NOTE FOR PUBLIC WORKS SUBCOMMITTEE OF FINANCE COMMITTEE

Supplementary Information on 389RO - Enhancement of public facilities at Ngong Ping, Lantau

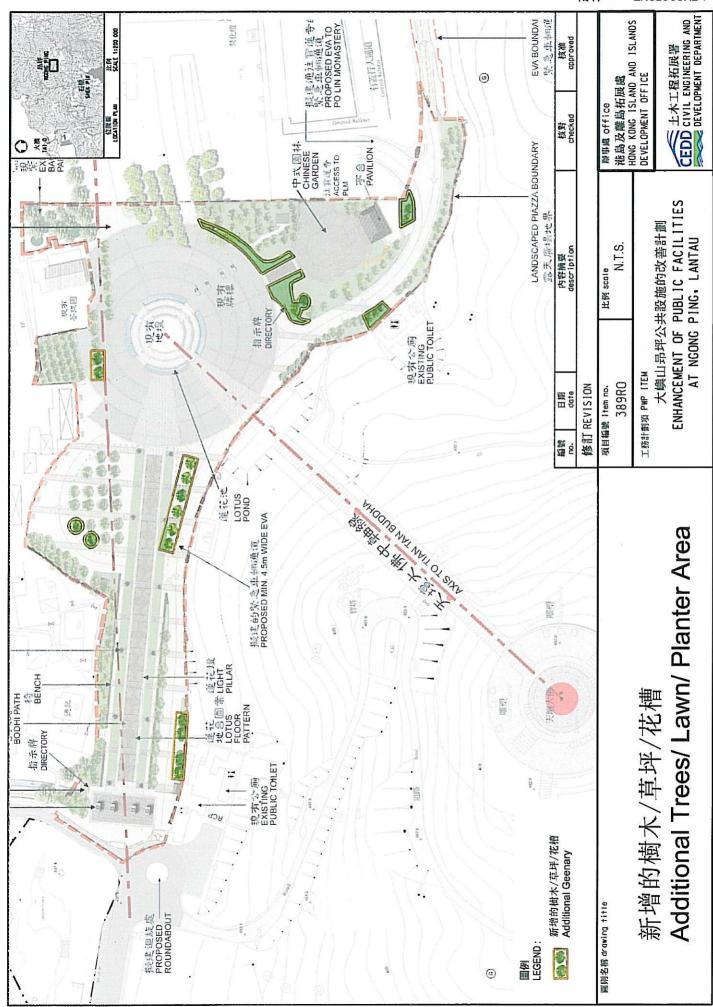
- 5. Some Members were concerned about the adequacy of toilet provision in the Ngong Ping area. At present, there are four public toilets managed by the Food and Environmental Hygiene Department (FEHD) and Ngong Ping 360 in the Ngong Ping area, and their locations are shown in Enclosure 2. Altogether they provide 22 cubicles and 30 urinals for male visitors, 43 cubicles for female visitors and five cubicles for visitors with a disability. According to the Hong Kong Tourism Board (HKTB) and Travel Industry Council of Hong Kong (TIC), they have not received any complaint about toilet provision at the Ngong Ping area.

- 6. In anticipation of visitor increase, we propose to provide an additional public toilet in the area. The proposed public toilet will provide an addition of five cubicles and eight urinals for male visitors, 10 cubicles for female visitors and one cubicle for visitors with a disability. The total provisions are detailed in Enclosure 3. With the additional toilet, the overall handling capacity

of public toilets in the area will be increased from about 4 200 to 5 200¹ visitors per hour. Having regard to the short distance of 570 m between the Ngong Ping 360 Terminal and the entrance of PLM, we consider that the public toilet facilities in the area are sufficient to meet the anticipated demand in the area. We will provide clear signage to facilitate visitors to locate the nearby toilets, which should be within a walking distance of about five minutes from any location in the Ngong Ping area. We will continue to review the situation in consultation with the travel industry in order to better meet our visitors' needs.

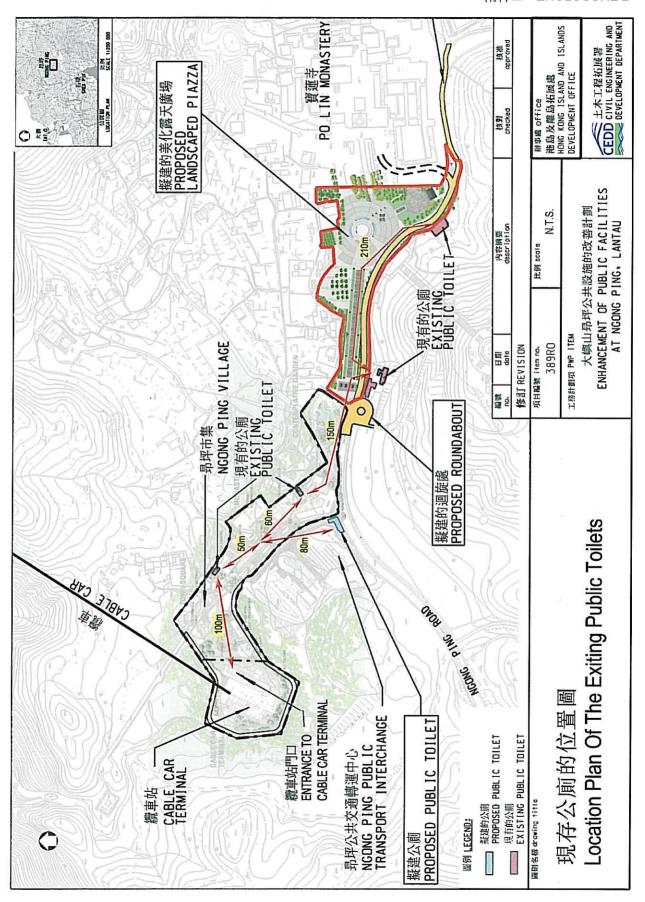
- 7. On the use of the future EVA, we have discussed Members' concern with PLM. To provide alternative access to PLM, we propose to upgrade an existing van track now serving the local villages, as shown in the layout plan at Enclosure 4. Currently, the van track only provides for single-lane traffic. The proposed upgrading will include repairing and provision of passing bays to improve flow capacity. The estimated capital cost for the upgrading works is about \$1 million, which will be funded outside the project estimate. The District Office (Islands) has pledged to implement this under the Rural Public Works Programme. Subject to necessary approval, it is envisaged that the minor works will commence in July 2008 for completion before the end of this year, well before the completion of the proposed Piazza.

- 8. This alternative is welcomed by PLM. After completion of the upgrading works, PLM has pledged that its vehicles will use the van track for daily operation. The proposed EVA will be managed by the Leisure and Cultural Services Department (LCSD) upon completion for use by vehicles for emergency and exceptional purposes. LCSD will work out with PLM a practical arrangement, with a view to diverting traffic to the improved van track and minimising the use of the proposed EVA.
